SP #79, Rosslyn Holiday Inn

Major Site Plan Amendment, Rezoning, and Vacation

Department of Community Planning,
Housing, and Development
Site Plan Review Committee #1
April 1, 2019

Density exclusions

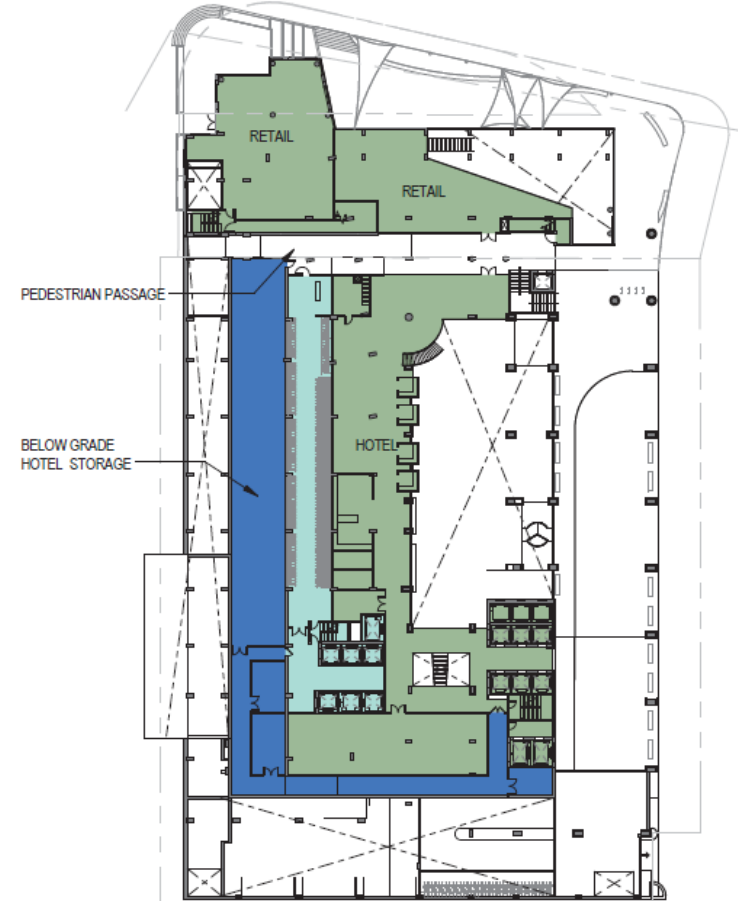
Requested Density Exclusions:

- 35,509 sf of exclusions requested
- Requested for below-grade mechanical and utility rooms, hotel storage, and vertical shafts that vent through the roof.
- Must be consistent with Zoning Administrator Memorandum on Density Exclusions.

Tower Separation

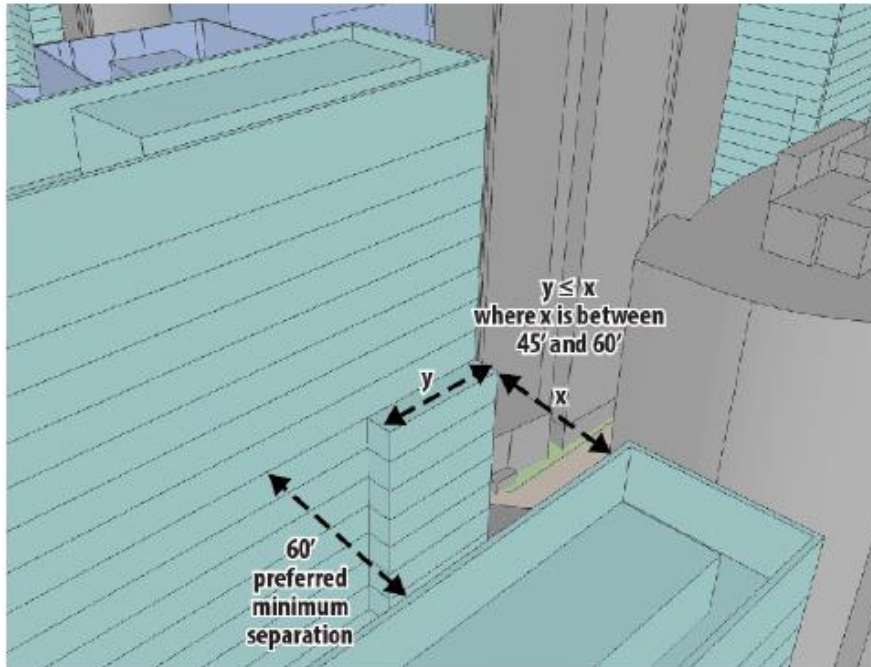
Towers should typically be separated by at least 60 feet. Separations as narrow as 45 feet can be considered, but should extend along the facade a distance no greater than the tower separation distance.
